Serial No.: 10/664,818

REMARKS

Amendments to the Drawings:

Page 13 of 14
Appl. No.: 10/664,818
Amendment in Reply to Office action of February 13, 2006
Annotated Sheet Showing Change(s)

FIG. 2A

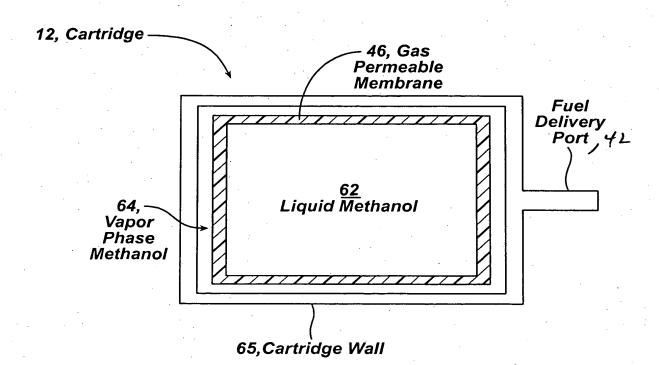
The examiner objected to the drawings because in figure 2A, reference number "42" was missing from the fuel delivery port and in figure 8, reference number "12" for the powered device should be changed to "10".

The examiner objected to the drawings because in figure 2A, reference number "42" was missing from the fuel delivery port and in figure 8, reference number "12" for the powered device should be changed to "10".

Corrected drawing sheets are enclosed herein in reply to the Office action.

In Figure 2A, reference number 42 was added.
